F. Lime Lakes Energy, LLC, Case No. 14-2250-EL-REN

Summary: Reply electronically filed by Mr. Bruce Bailey on behalf of Lime Lakes Energy, LLC

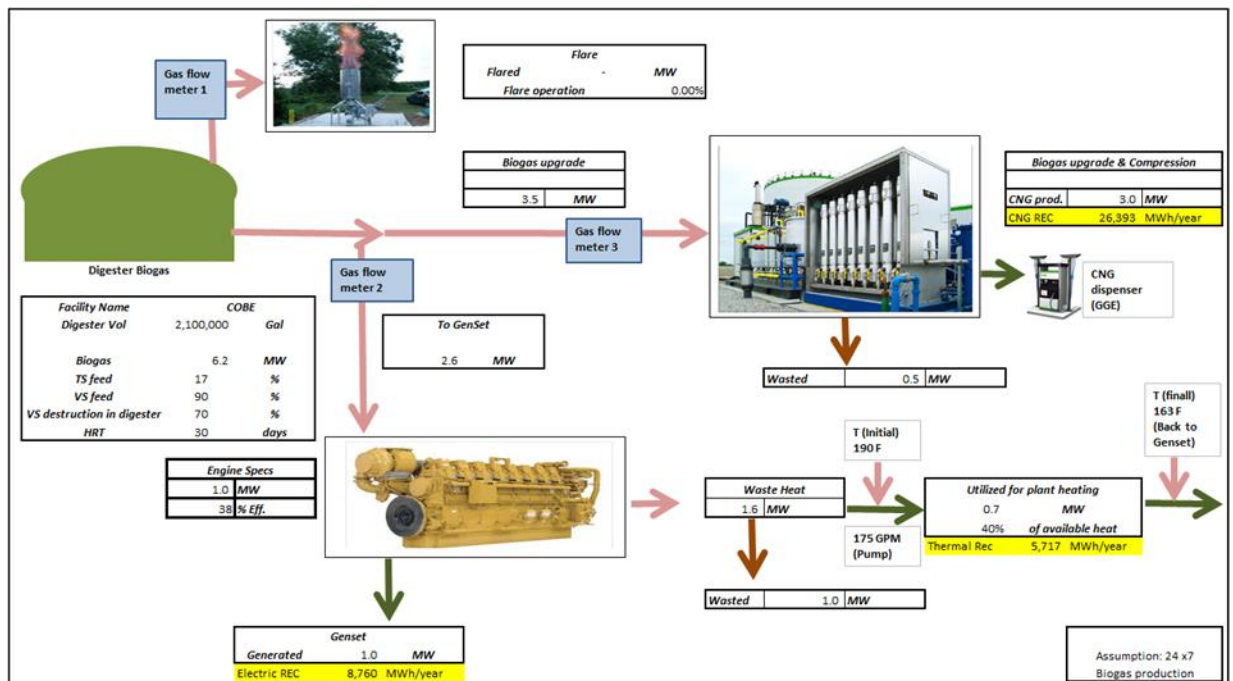
13. Regarding Section G.3 of the application, please provide a detailed description of how heat captured by each source is going to be measured and verified, including the configuration of the meter(s), the meter types(s), and meter accuracy. What is the projected in-service date of the thermal meters? Please provide documentation.
Thermal REC: Engine is cooled using a heat loop which circulates Glycol-Water mixture (50%) across the plant. The flow of the glycol is **175 GPM** (Pump rating, see fig.).

We have temperature sensor located in the engine which show the temperature of glycol taking waste heat from the engine. **The temperature is typically around 190° F (See fig. 1)** This glycol flows in the plant supplying heat for plant purpose (Digester heating, Floor heating, Pasteurization). **The return temperature of glycol is around 163° F (See fig. 1)**

$$\text{Heat utilized in the plant } \frac{\text{BTU}}{\text{min}} = 1,460 \frac{\text{lbs}}{\text{min}} * (190 \text{ F} - 163 \text{ F})$$

$$\text{Heat utilized in the plant } \frac{\text{BTU}}{\text{min}} = 39,808 \text{ BTU/min}$$

$$\text{Heat utilized in the plant } \frac{BTU}{hr} = 39,808 \frac{BTU}{min} * 60 \frac{min}{hr}$$

$$\text{Heat utilized in the plant } \frac{BTU}{hr} = 2,388,499 \frac{BTU}{hr}$$

$$\text{Heat utilized in the plant } MW = 2,388,499 \frac{BTU}{hr} * \frac{\left(\frac{1}{3412142}\right) MW}{BTU} / hr$$

$$\text{Heat utilized in the plant } MW = 0.7 \text{ MW}$$

$$\text{Thermal REC } \left(\frac{MWh}{yr}\right) = 0.7 \text{ MW (Thermal utilization)} * 24 \frac{h}{day} * 365 \frac{days}{yr}$$

$$\text{Thermal REC } \left(\frac{MWh}{yr}\right) = 5,717 \text{ MWh/year}$$
